## PCN#20200904000.1 Qualification of HFTF as an additional assembly site for select Devices Change Notification / Sample Request

Date:September 09, 2020To:FLEXTRONICS PCN

<b>PCN Number:</b> 20200904000.1			PCN			Date:	Sept 09, 2020	
Title: Qualification of HFTF as an additional assembly site for select Devices								
Customer Contact: PCN Manager		<u>Manager</u>	Dept: Quality Services					
Proposed 1 <sup>st</sup> Ship Date: Dec		Dec 09, 2	Dec 09, 2020 Esti		Estim	nated Sample Availability:		Date provided at sample request
Change Type:								
Assembly Site			Design			Wafer Bump Site		
Assembly Process			Data Sheet			Wafer Bump Material		
Assembly Materials			Part number change			Wafer Bump Process		
Mechanical Specification			Test Site			Wafer Fab Site		
Packing/Shipping/Labeling			Test Process			Wafer Fab Materials		
Wafer Fab Process								
PCN Details

Example:

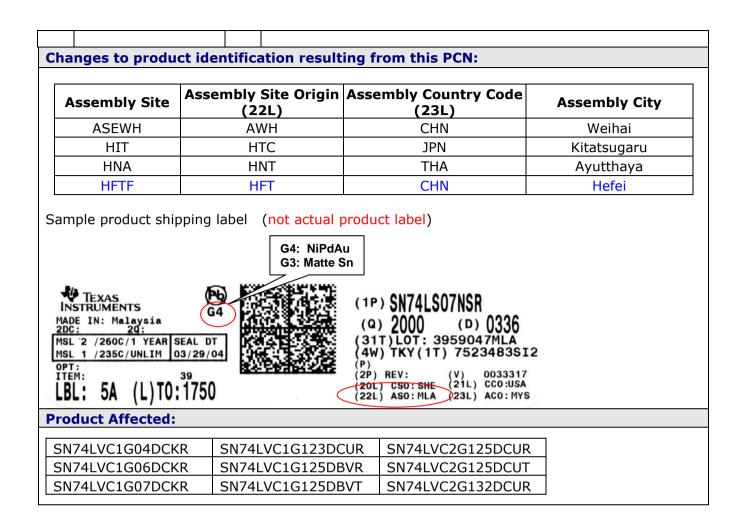
Upon expiry of this PCN TI will combine lead free solutions in a single <u>standard part number</u>, for the devices in group 2. For example; <u>SN74LVC1G04DCKR</u> – can ship with both Matte Sn and NiPdAu. When available customers may specify NiPdAu finish by ordering the part with the G4 suffix, e.g. **SN74LVC1G04DCKRG4**."

Customer order for 7500 units of *SN74LVC1G04DCKR* with 2500 units SPQ (Standard Pack Quantity per Reel).

- TI can satisfy the above order in one of the following ways.
  - I. 3 Reels of NiPdAu finish.
  - II. 3 Reels of Matte Sn finish
  - III. 2 Reels of Matte Sn and 1 reel of NiPdAu finish.
  - IV. 2 Reels of NiPdAu and 1 reel of Matte Sn finish.
